Access Compliance Report Public Rights-of-Way (Curb Ramps)

Main Street: HEWES_ST Cross Street: BOND_AVE Location: NE

ADA ID: RPAT211027140636 Ramp Type: Type 1 - Perpendicular Diagonal Initial Pass/Fail: Pass Overall Compliance: No Severity Score: 0

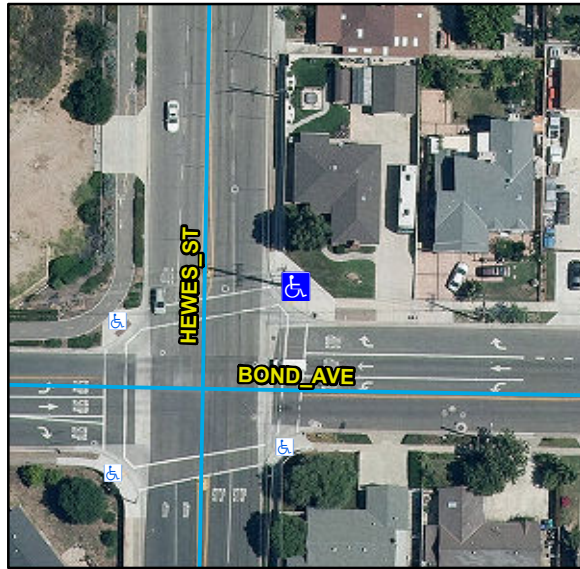
Compliance	Description	Data	Compliance	Description	Data
N/A	Ramp Length (in)	116	N/A	Flare Type LT	
Yes	Ramp Width (in)	50			Sloped
Yes	Ramp Run Slope (%)	7.5	N/A	Flare Slope LT (%)	6.4
Yes	Ramp Cross Slope (%)	0.5	N/A	Flare Traversable LT	No
N/A	Landing Present	Yes	N/A	Flare Type RT	
N/A	Landing Length (in)	71			Sloped
Yes	Landing Width (in)	48	Yes	Flare Slope RT (%)	7.5
Yes	Landing Run Slope (%)	1.4	N/A	Flare Traversable RT	Yes
Yes	Landing Cross Slope (%)	0.4	Yes	DWS Provided	Yes
N/A	Landing Movement Obstructed?	No	Yes	DWS Contrast	Yes
	Landing Movement Type	N/A	Yes	DWS Length (in)	36
N/A	Landing Shared	No	Yes	DWS Full Width	Yes
Yes	Clear Space	Yes	Yes	DWS Offset Left (in)	0
Yes	Clear Space To Crosswalk (in)	48	Yes	DWS Offset Right (in)	N/A
N/A	Marked Crosswalk 1	Yes	N/A	Marked Crosswalk 2	Yes
	Crossing 1 Direction	W		Crossing 2 Direction	S
	Marked Crosswalk 1 Width (in)	120		Marked Crosswalk 2 Width (in)	120

Yes	Ramp Inside Crosswalk 1	Yes	Yes	Ramp Inside Crosswalk 2	Yes
	Crossing 1 Slope (%)	1.9		Crossing 2 Slope (%)	0.2
	Crossing 1 Cross Slope (%)	1		Crossing 2 Cross Slope (%)	0.6
Yes	Gutter Ponding	No	No	Curb Slope	11.4
Yes	Gutter Lip Height (in)	0		Road Run Slope (%)	0.6
Yes	Gutter Run Slope (%)	3.6		Road Cross Slope (%)	0.9
Yes	Gutter Cross Slope (%)	0.1			
Yes	Overall Surface Condition: Acceptable		Yes	Perp Joint Present	Yes
	Cross Gutter Present?	Yes		Spandrel Present?	Yes
	Replace Cross Gutter?	No		Replace Spandrel?	No

Remove & Replace Curb Slope.

R304.2.2, STD 1115
